MEMORANDUM

SUBJECT: City Hall: Essential Facility Classification

PROJECT: Cupertino City Hall Investigation

FLOOR PLAN - MAIN LEVEL

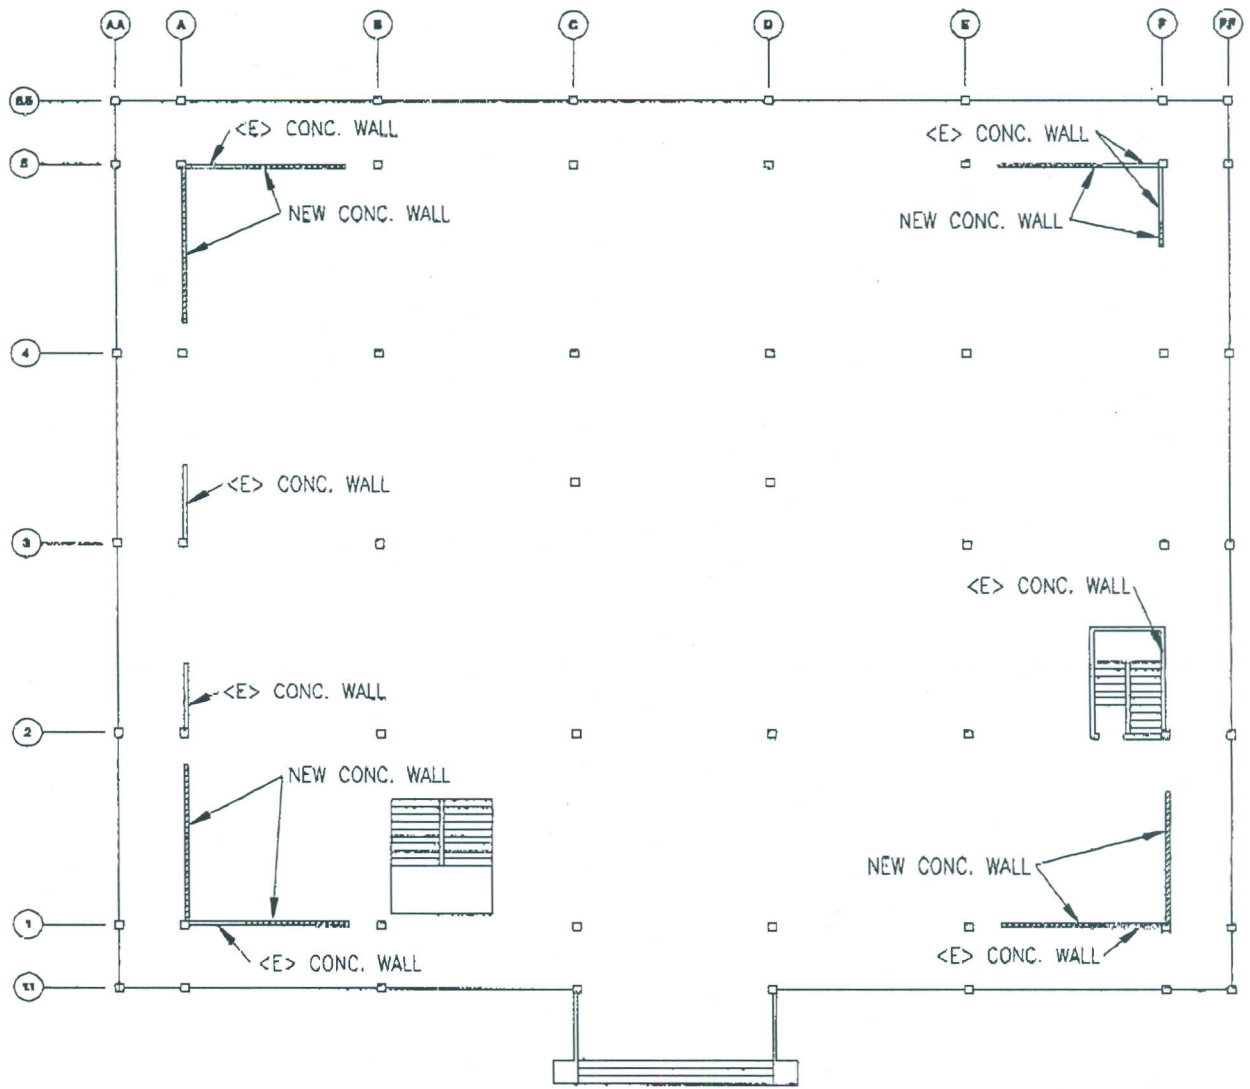
Our analysis shows that the existing structure generally has the strength to resist the required loads. The exception to this is the second level exterior concrete shear walls. These shear walls are considerably overstressed and do not meet the ductility requirements of the current Code. These shear walls would not be allowed to be constructed today. A significant amount of new concrete walls need to be added to the existing structure to bring the building into conformance with the current Code. Enclosed is a preliminary drawing indicating recommended locations of wall additions.

A rough cost estimate for the work of adding approximately 110 feet of new concrete shear wall, per the enclosed plan, is \$130,000. This represents approximately \$1,180.00 per foot of wall. This includes demolition of the existing stud walls, new concrete walls, furring the interior with gypsum board, painting, minor ceiling, floor and electrical work.
